**LAKE MANITOBA AND LAKE
ST. MARTIN OUTLET CHANNELS
PROJECT
Environmental Impact Statement
May 2023 Project Description
Update**

**PROJECT DESCRIPTION
UPDATE**

**LAKE MANITOBA AND LAKE ST. MARTIN OUTLET CHANNELS PROJECT
ENVIRONMENTAL IMPACT STATEMENT
MAY 2023 PROJECT DESCRIPTION UPDATE**

Figure 3C-11a LMO Water Control Structure - General Arrangement Plan

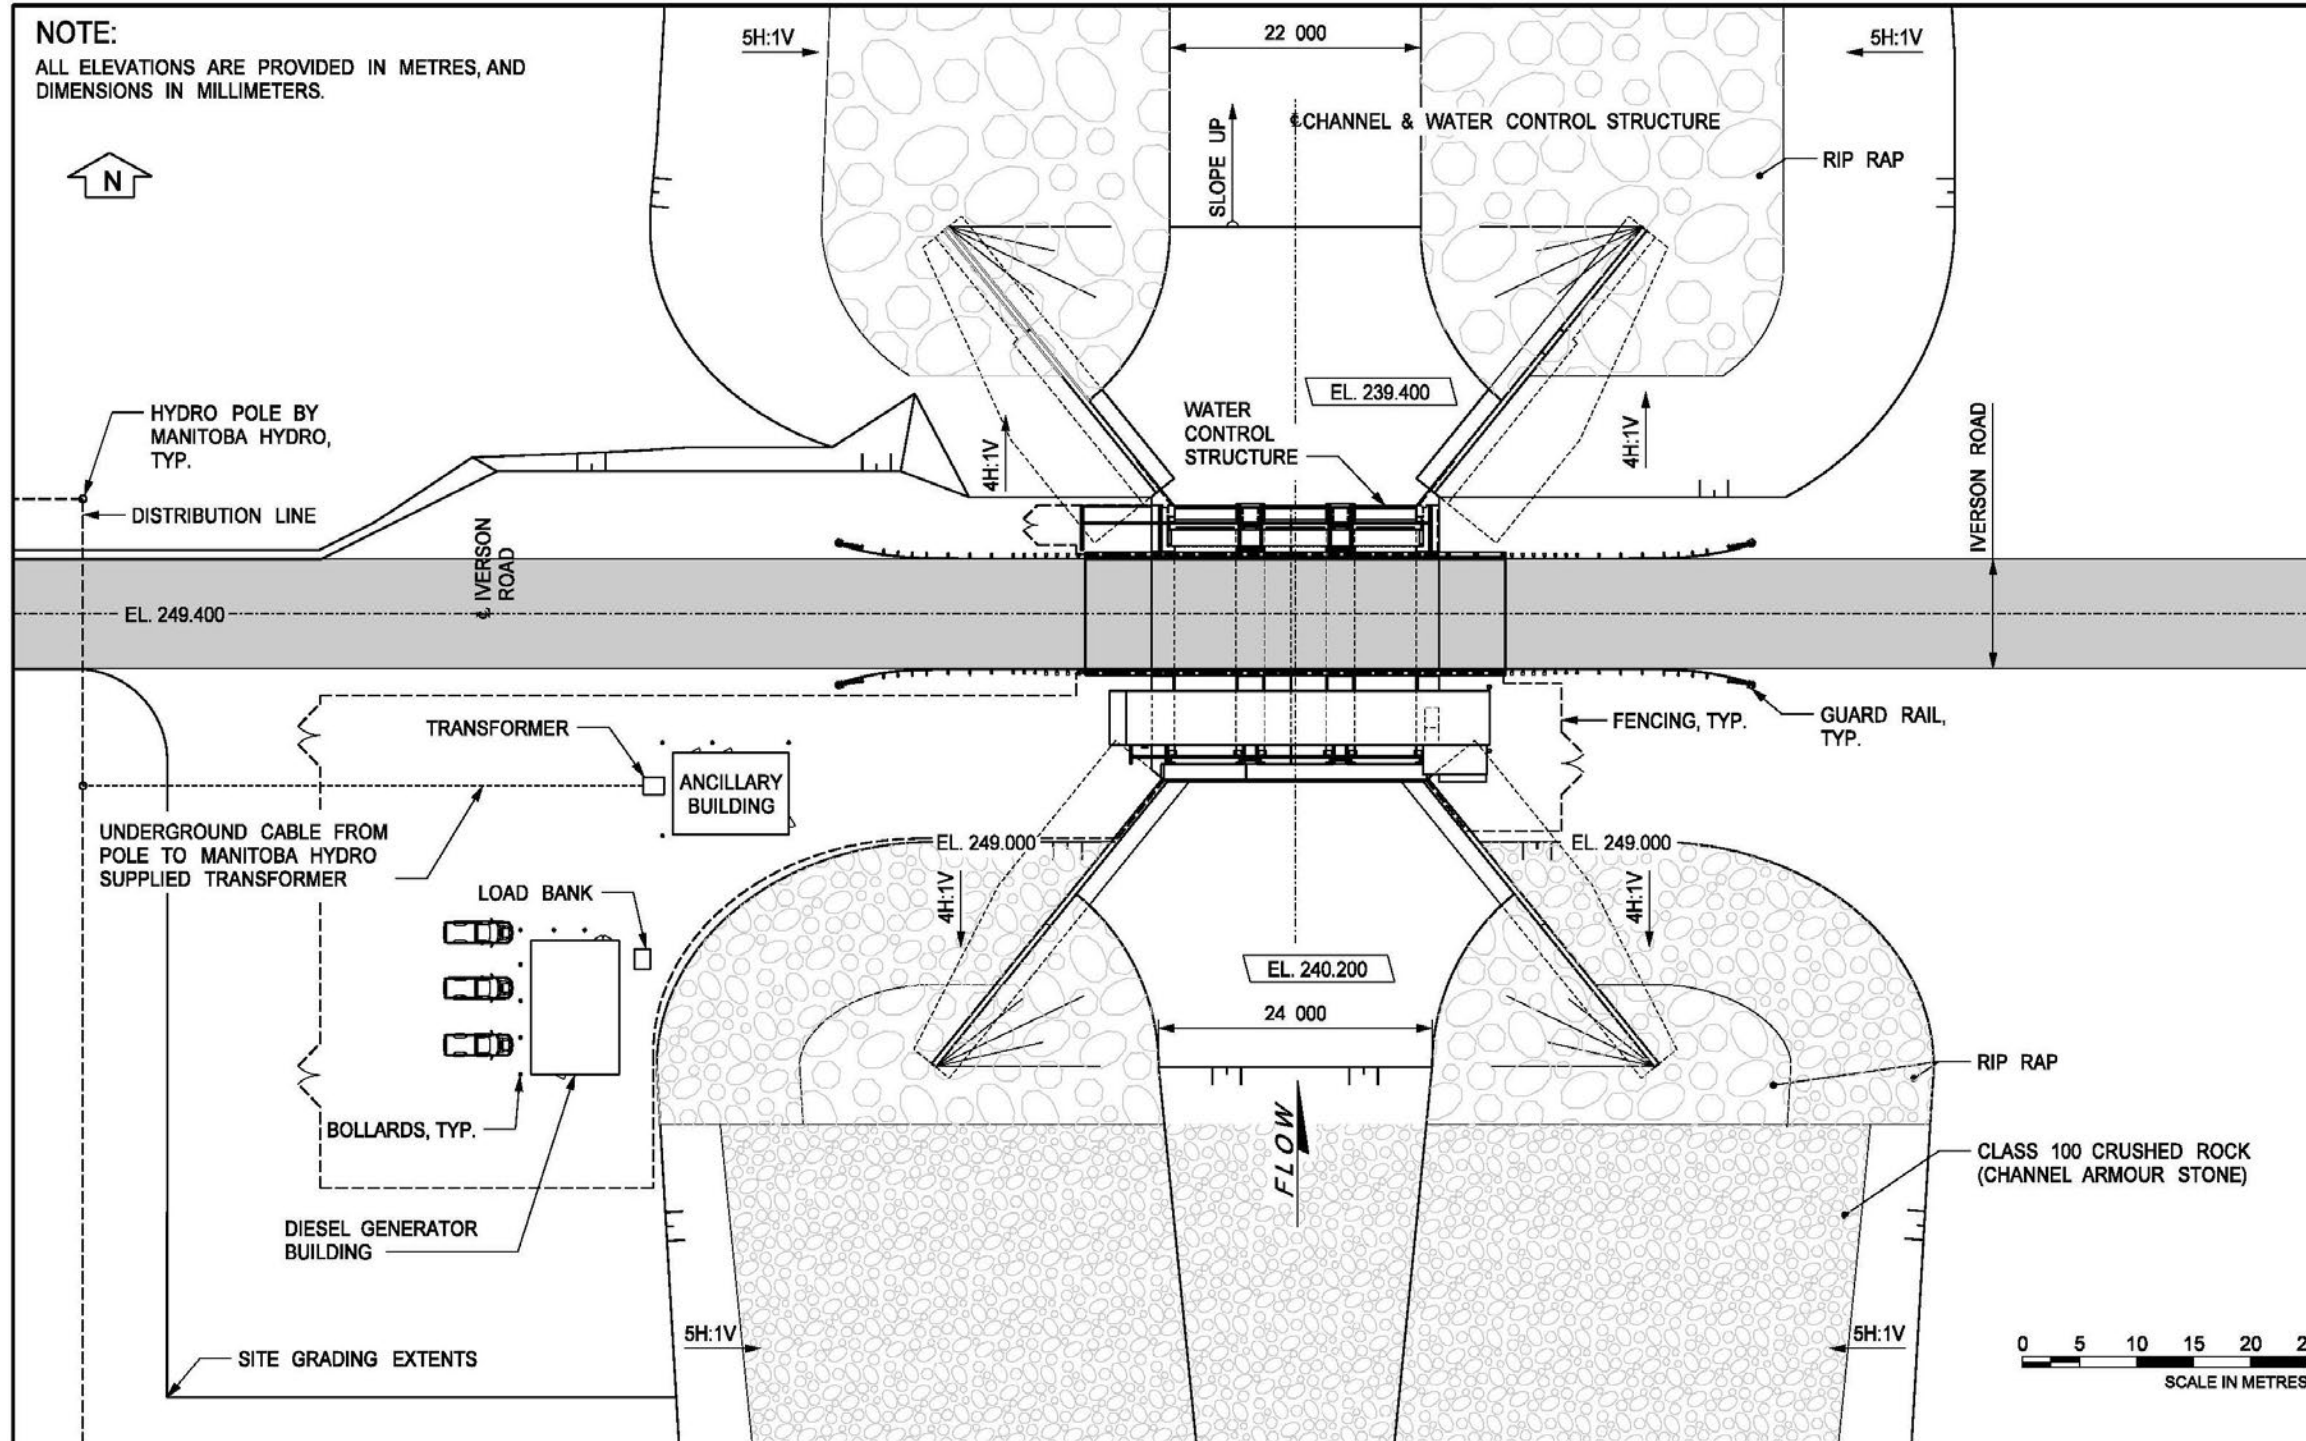
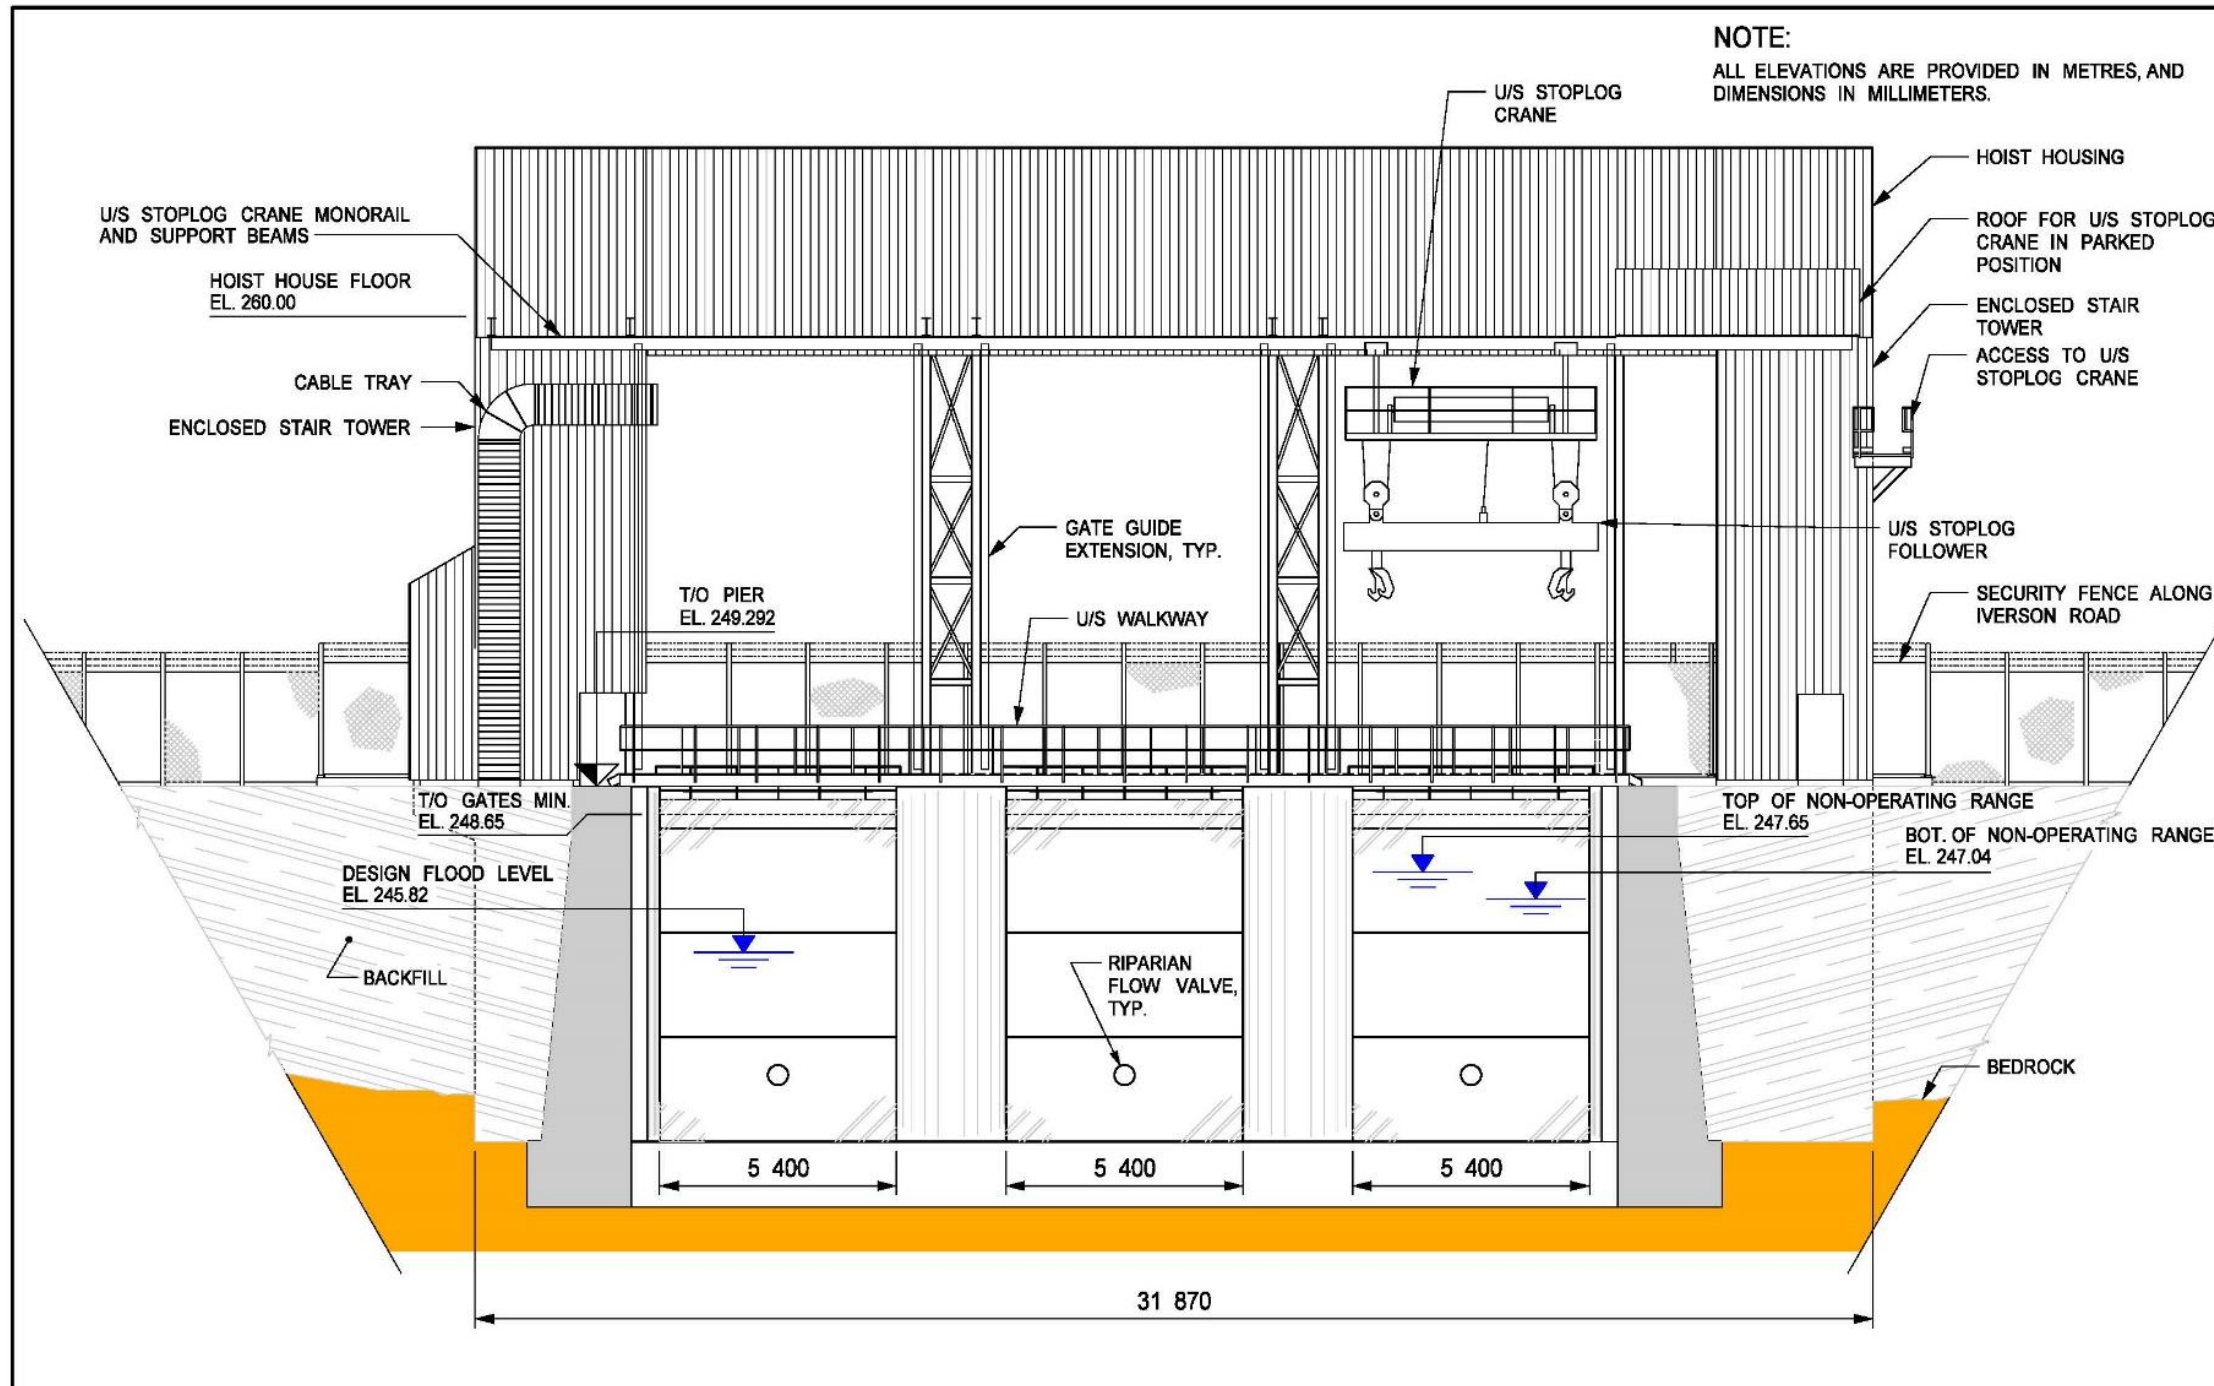
Several refinements in WCS design have been made since the March 2020 Project EIS, as shown in Appendix 3C, Figure 3C-11a, 3C-11b, and 3C-11c. The WCS is still designed with three sluice bays, guides, and sill beams for upstream stoplogs, vertical lift gates and downstream stoplogs; however, the bays are now narrower (5.4 m [17.7 ft], down from 9 m [29.5 ft]) and a stoplog crane and support structure have been added downstream of the bridge deck. The WCS will have a base slab founded on bedrock to support the mass of the concrete substructure and a stilling basin with baffle blocks. The stilling basin and baffle blocks are designed to absorb or dissipate the energy from the flowing water and protects the downstream area from erosion.
